Modification of Development Consent

Section 4.55(2) of the *Environmental Planning and Assessment Act 1979*

Applicant Number:	SSD 7348
Applicant:	Goodman Property Services (Aust) Pty Ltd
Consent Authority:	Minister for Planning and Public Spaces
Site	Lot 1 DP 663937, Lot 2 DP 1215268, Lot 6 DP 229784, Lot 2 DP 84578, Lot 3 DP 85393 and Lot 11 DP 1178389 2 Aldington Road, Kemps Creek NSW 2178
For the following:	<p>A Concept Proposal including:</p> <ul style="list-style-type: none">• concept layout of 22 warehouse buildings inclusive of dock offices and ancillary offices providing 476,000 square metres of gross lettable area, built over five development stages;• concept layout of development lots, internal roads, drainage, landscaping, noise walls, basins and biodiversity offsets; and• development controls <p>A Stage 1 Development including:</p> <ul style="list-style-type: none">• bulk earthworks across all five stages including retaining walls and noise walls;• lead in services including but not limited to drainage, power, sewer, water and telecommunications;• service infrastructure to Precinct 1, including drainage, power, sewer, water and telecommunications;• construction and op

Figure 3: Stage 1 DA Layout

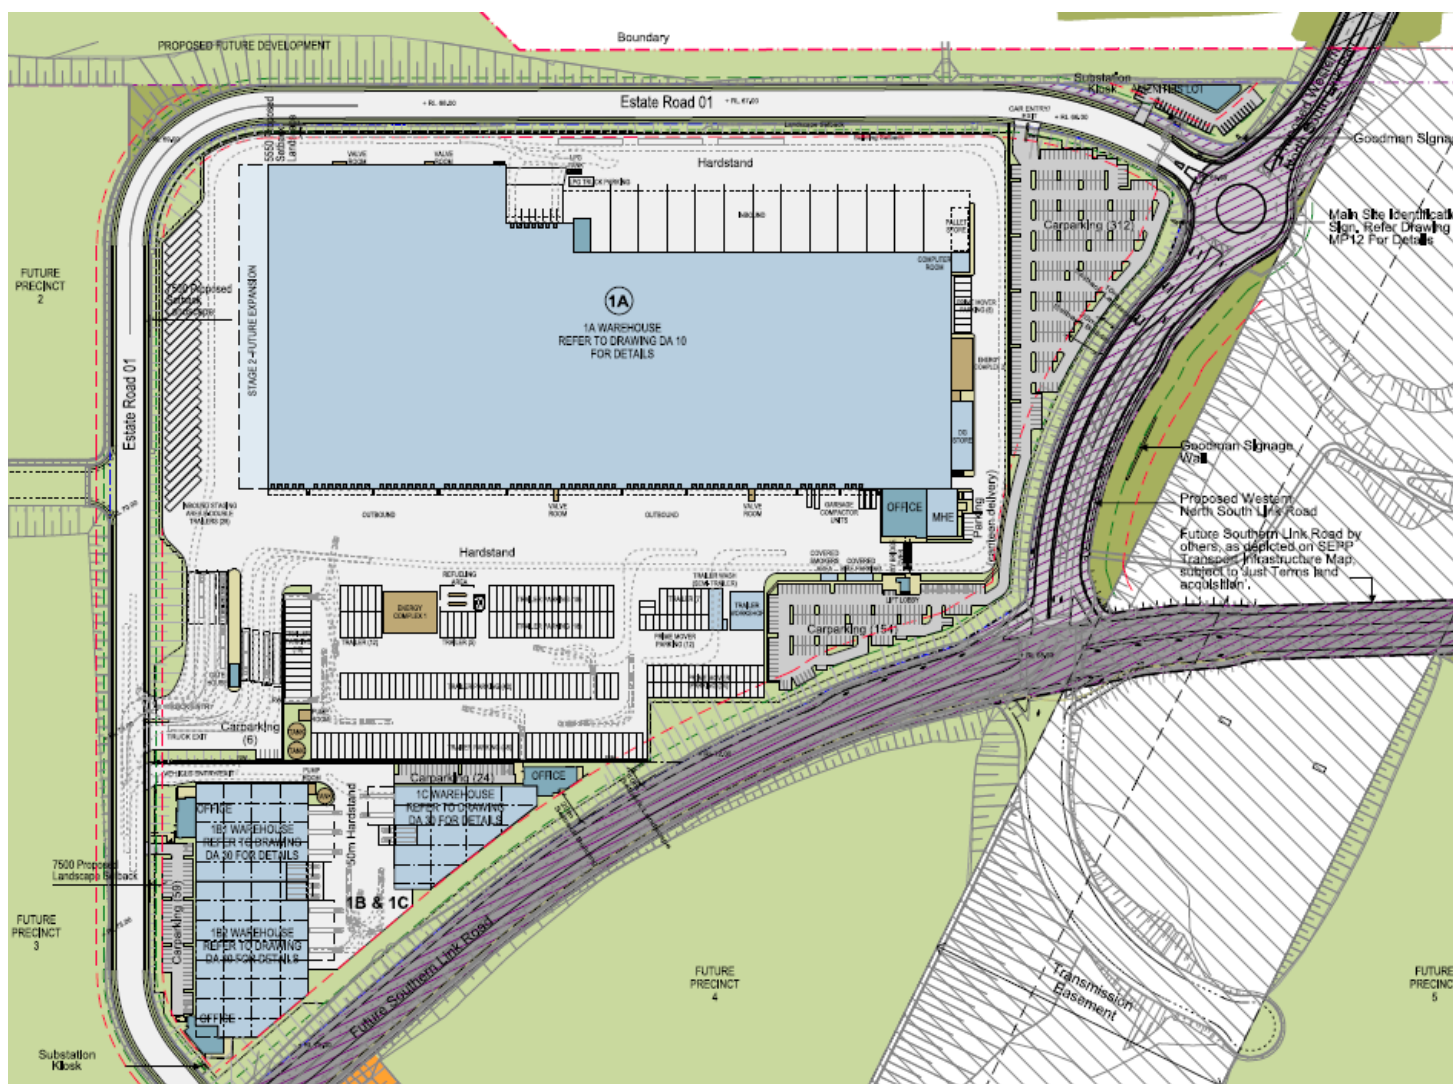
25. Replace Figures 3, 4 and 5 in Appendix 2 with two new figures as follows:

Figure 1B: Noise Receivers and Noise Wall Locations (MOD 2)

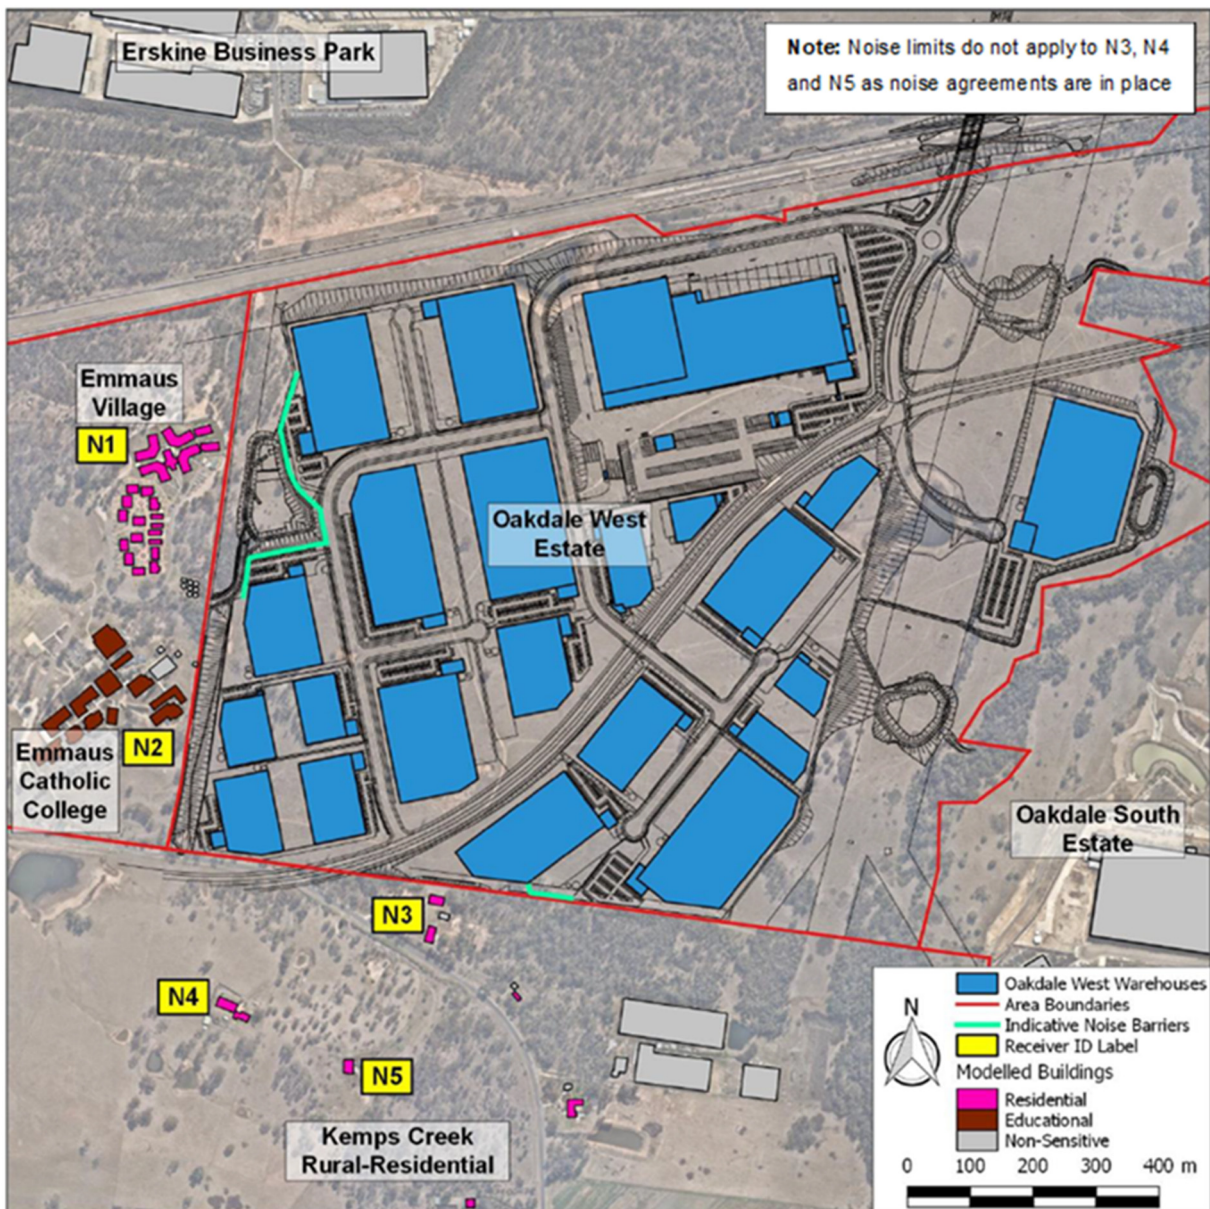
- Noise Barrier**
- D75(c) The Applicant must install the noise barrier as shown on Figure 7B in Appendix 5, no later than 31 October 2020, unless the noise barrier is installed in accordance with Condition D75(a).

26. Insert new Figure 7B in Appendix 5 as follows:
